MOTHERBOARD

Generic 9U VME/PCI Motherboard - 1/14/2000 - E. Hazen

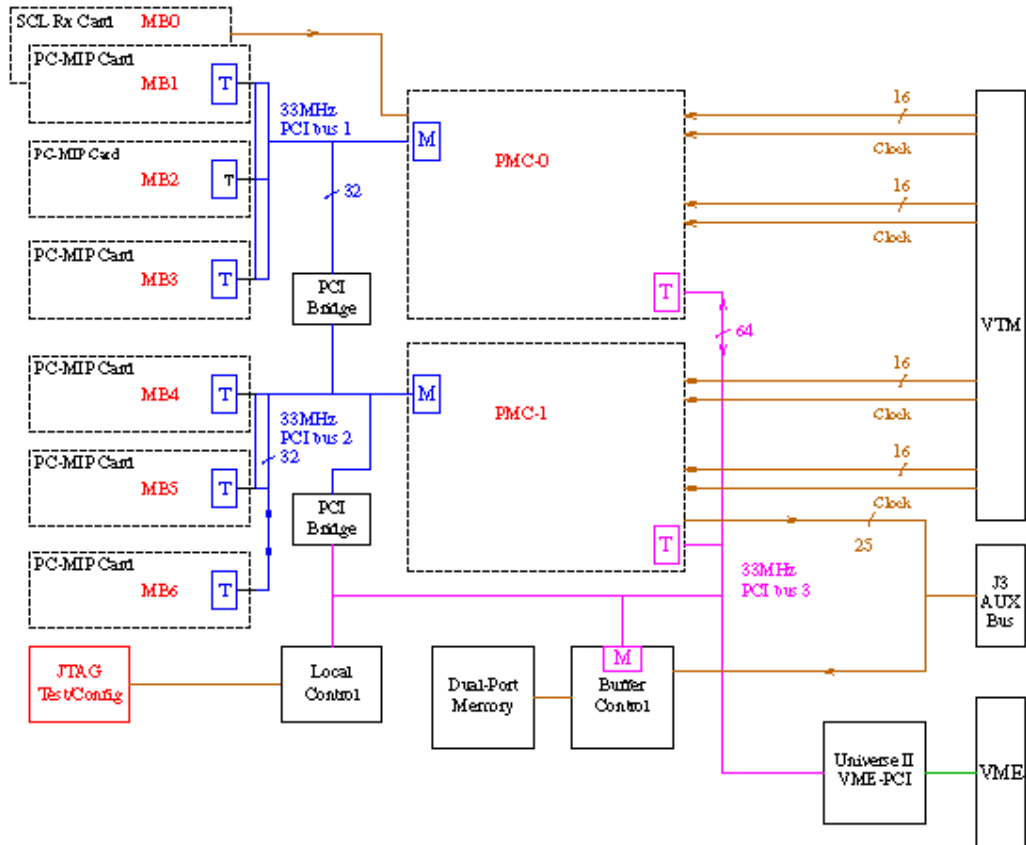
Rev 1/14/2000 - add Universe II as VME-PCI bridge. See www.tundra.com for more details.

Three PCI busses are now connected by bridges. Buffer/multiplex removed between VTM and PMC.

Local control block is now a PCI slave, so VME only goes to the Universe II.
